Memorandum

SUBJECT: Request for deviation: Sight  
distance at proposed intersection  
US 97, Vicinity MP 172.08 Left

**OLD BLEWETT BRIDGE No 1  
Bridge Replacement Project**

**Alternate Bridge Location  
Sight Distance  
on HWY. 97**

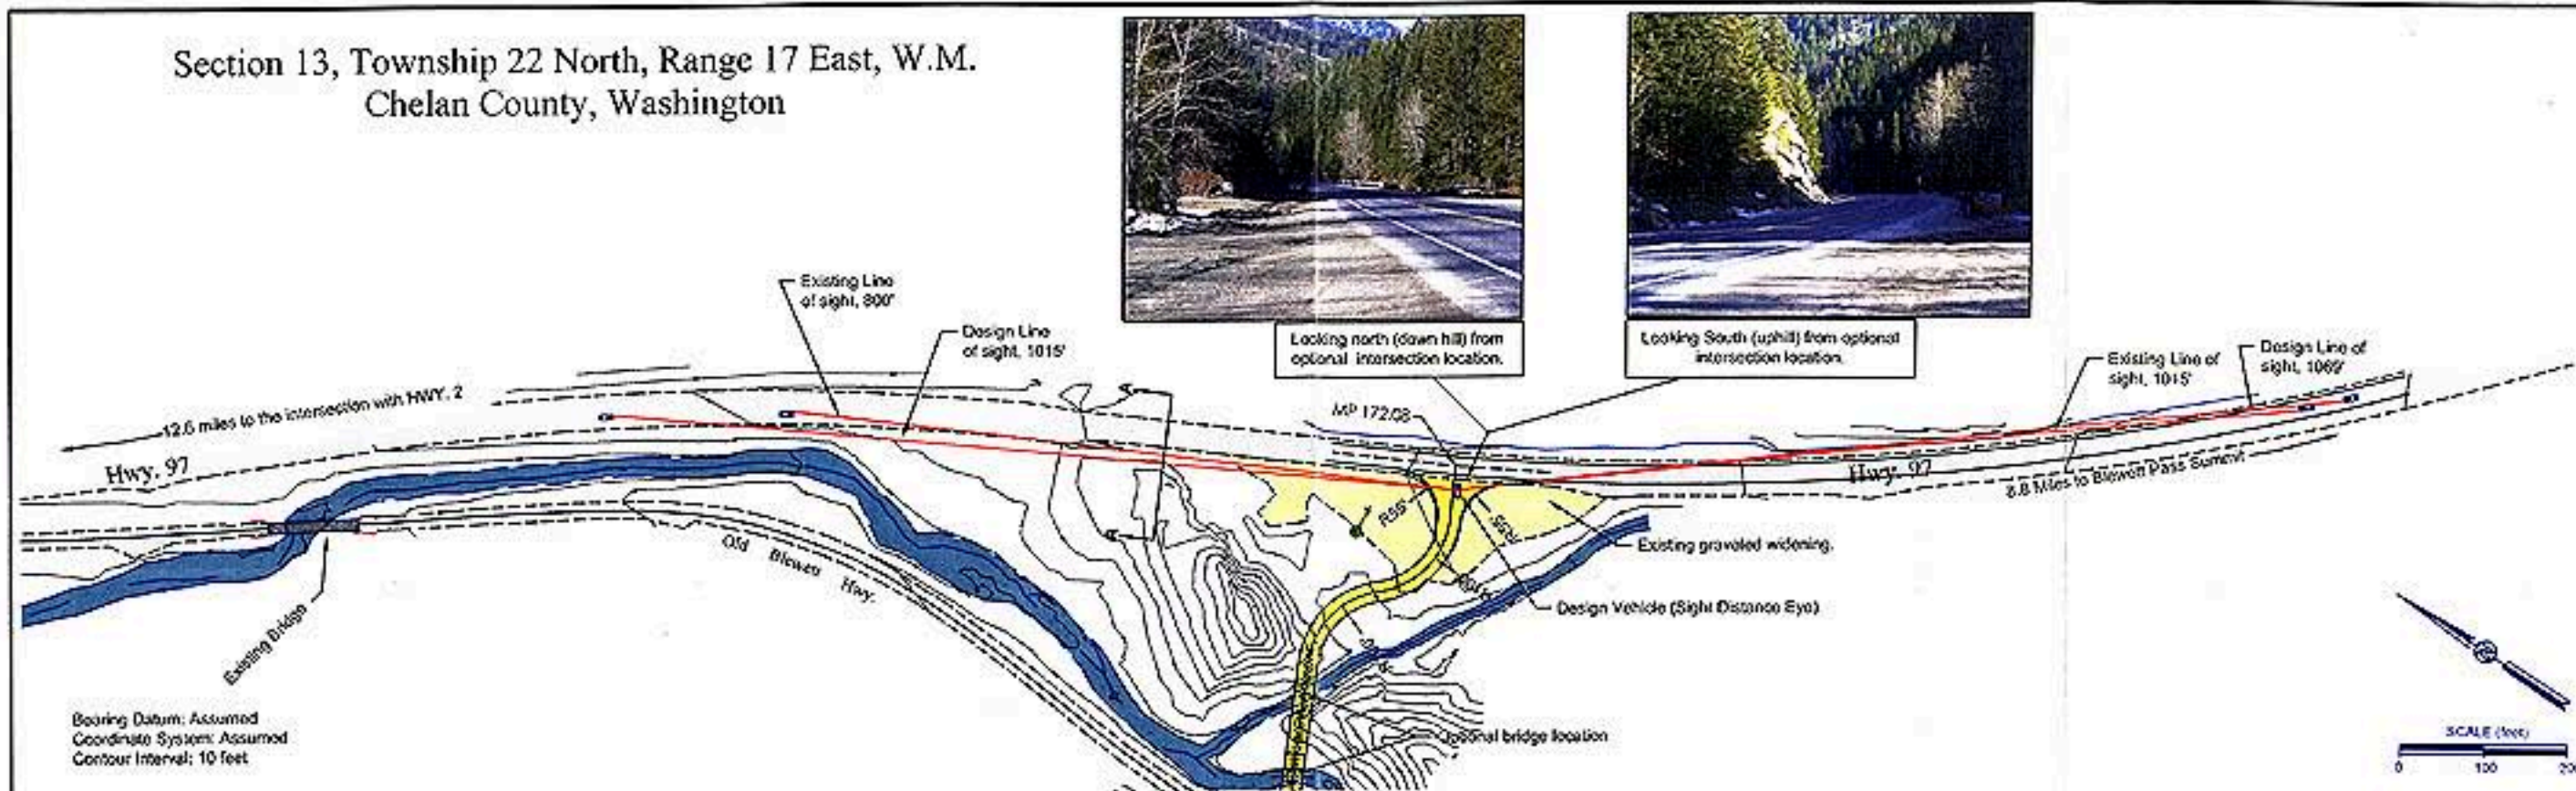
**Proposed Intersection Sight Distance available:** Intersection Sight Distance viewing traffic on US 97 coming from the north = 1015'. Intersection Sight Distance viewing traffic on US 97 coming from the south = 1069'

3. **Proposed Alternative: Relocate intersection approximately 2000 feet to the south:** The new intersection will be at 90 degrees. It will require slope excavation of approximately 1,600 cubic yards on State right-of-way to improve sight distance. A sight distance of 1,069 feet to the south and 1,015 feet to the north is achievable at a cost of approximately \$100,000.

- To bring the sight distance up to 1,100' to the south requires adding an additional 31' of sight distance. To achieve this would require a costly sliver cut to an existing rock cut that has an extremely high plateau. The sliver cut could result in future stability issues within the remaining rock.

- To bring the sight distance up to 1,100' to the north requires an additional 85' of sight distance. To achieve this would require trees to be removed and long-term maintenance of vegetation adjacent to Peshastin Creek. This removal would have an environmental impact within the existing buffer area of Peshastin Creek and could undermine US 97's fill slope resulting in significant impacts to the highway and Peshastin creek.

The recommendation of Chelan County Public Works is to deviate the horizontal intersection sight distance for the new intersection. Chelan County proposes to build a new intersection to US 97 from the Old Blewett Highway with a sight distance of 1,069 feet to the south and 1,015 feet to the north. These sight distances exceed current AASHTO standards but do not meet WSDOT more conservative design standards for a Single Unit truck, but does meet design standards for the majority of vehicles (passenger cars and light utility trucks) using the roadway.
